Service Campaign Bulletin

Campaign No. 2018090015, November 2018

SUBJECT: **Model G65 AMG vehicles (463 platform)**
Model Year 2018
Replace left air filter housing with bleed line

Figure 1

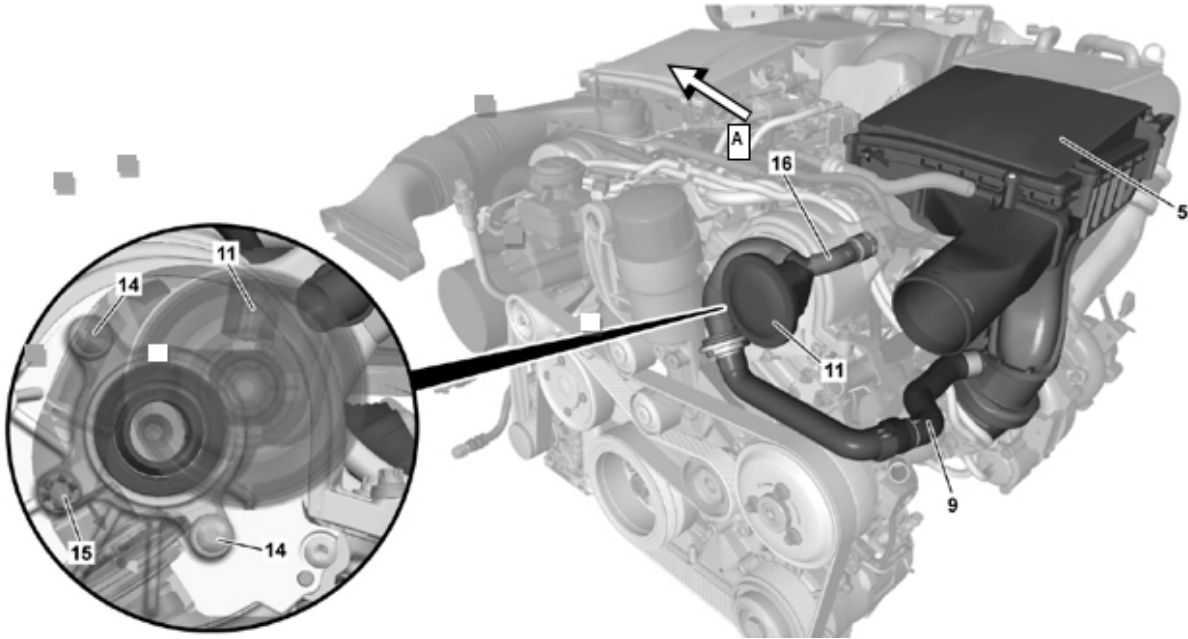
Daimler AG ("DAG"), the manufacturer of Mercedes-Benz vehicles, has determined that on certain MY18 G65 AMG vehicles, the purge air line for the left air filter housing may not meet US market specifications. An authorized Mercedes-Benz dealer will replace the left air filter housing on the affected vehicles.

1. Replace left air filter housing (A, figure 1) with bleed line (AR09.10-P-1150MUC).
